**RE: Rain Tunnel Car Spa
5401 Sevilla Ave NW
Drainage Report for Variance
Engineer's Stamp Date: 7/12/2018
Hydrology File: F11D016**

DRAINAGE AND TRANSPORTATION INFORMATION SHEET (REV 6/2018)

WATER BREAK VARIANCE REQUEST SUMMARY

CITY OF ALBUQUERQUE PUBLIC WORKS DIVISION ENGINEERING GROUP			
Rain Tunnel Car Spa WATER BREAK VARIANCE REQUEST EXHIBIT			
DESIGN REVIEW COMMITTEE	CITY ENGINEER APPROVAL	LAST DESIGN UPDATE	MO./DAY/YR.
CITY PROJECT NO.	ZONE MAP NO.	SHEET #	
730889	F-11-Z	1 of 1

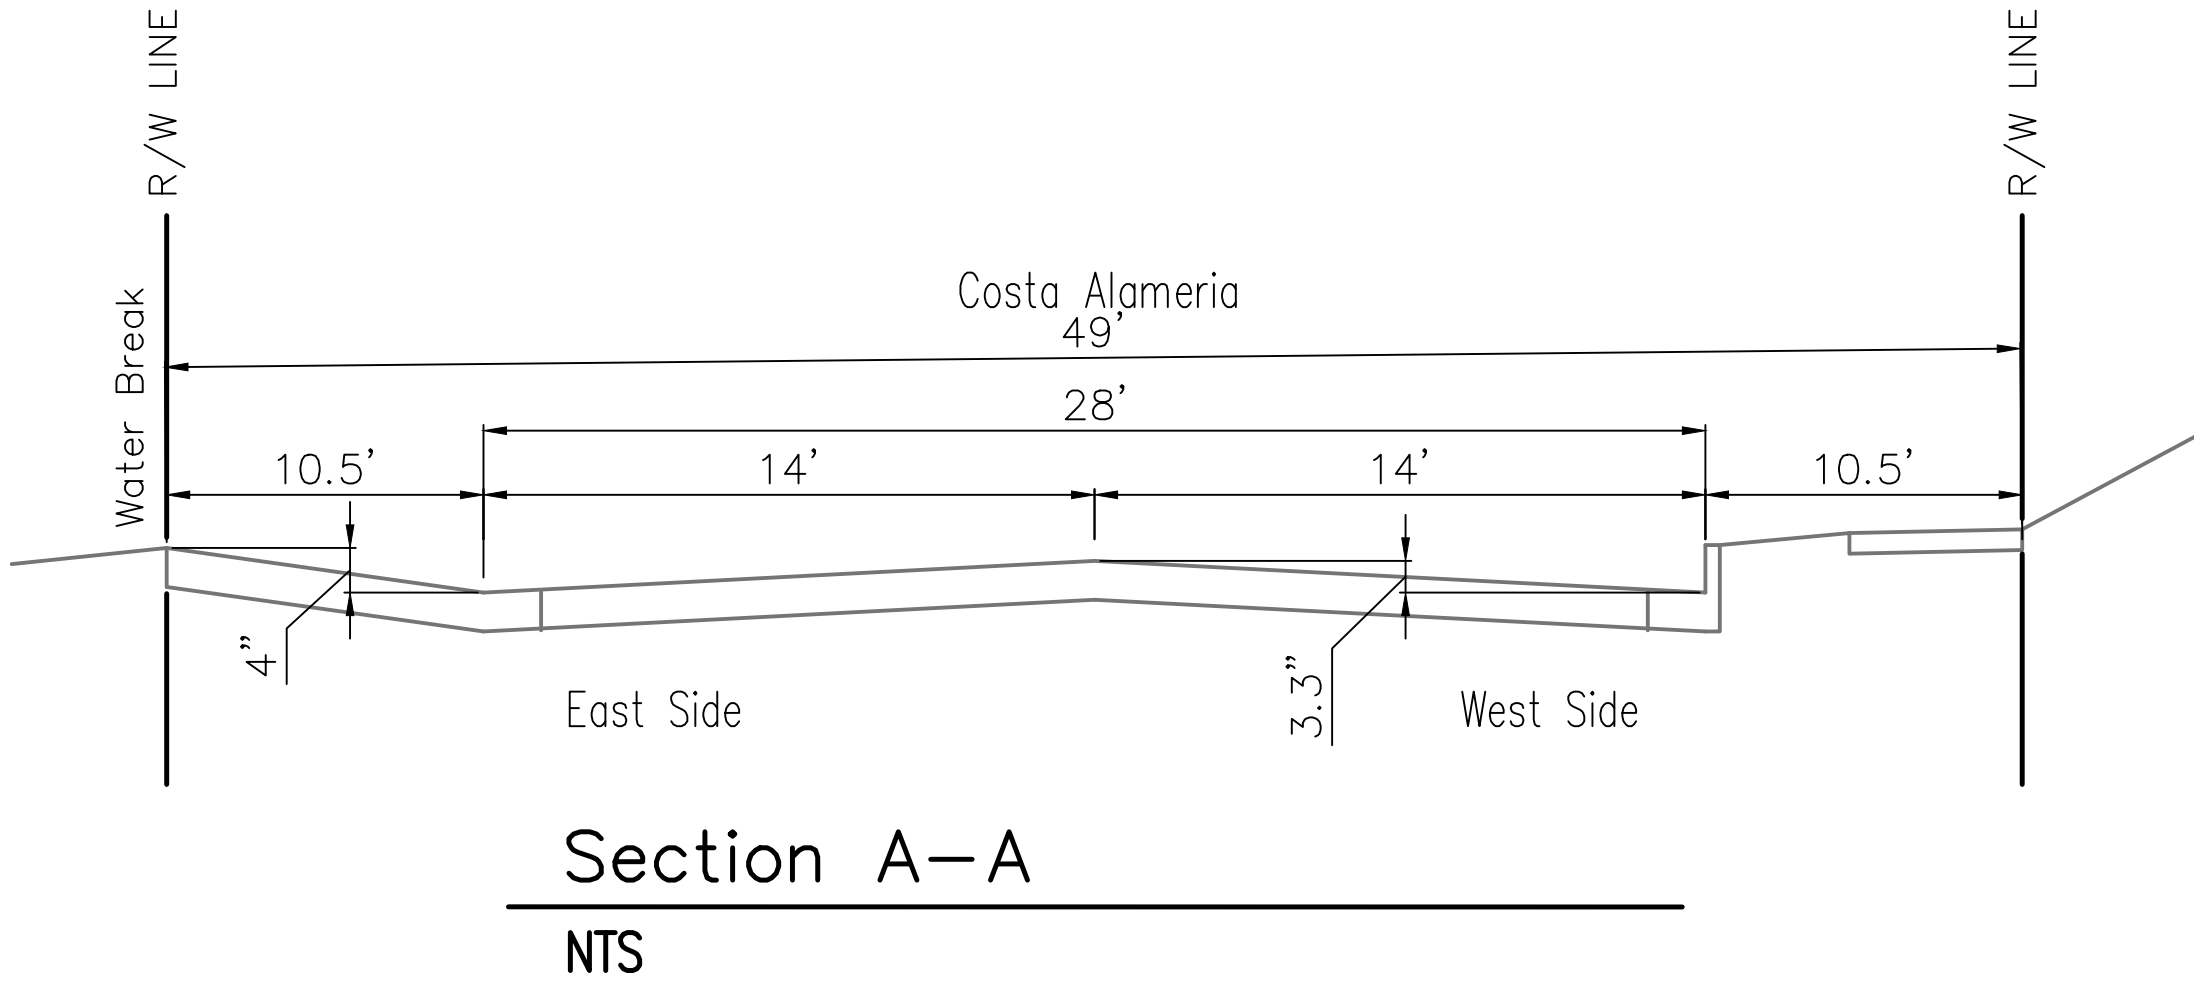
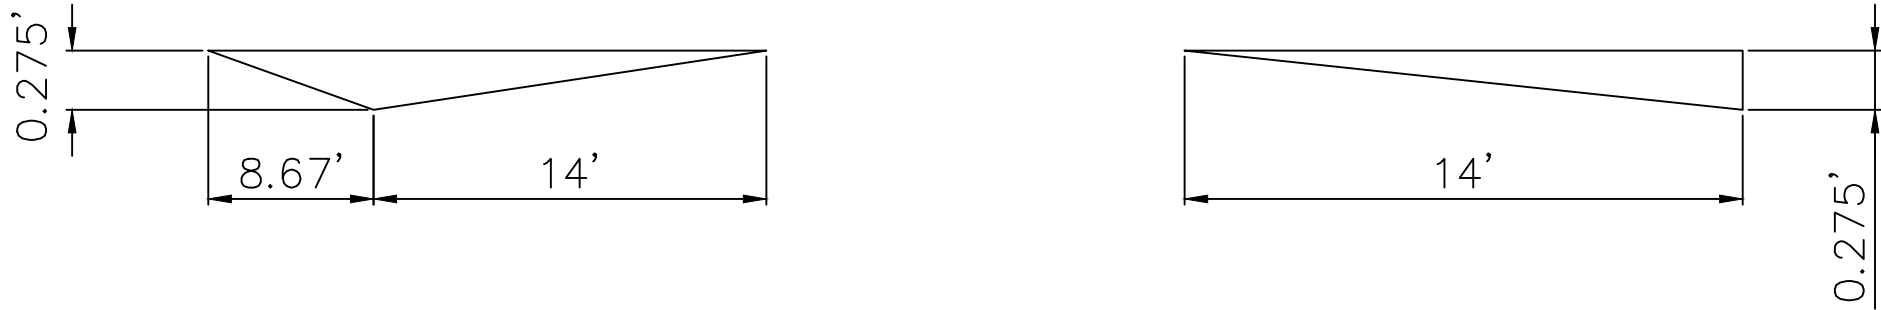
Based on the submittal received 7/12/18, the Drainage Report is approved for Work Order-Variance for a waterblock of 0.275' (3.3") minimum in height.
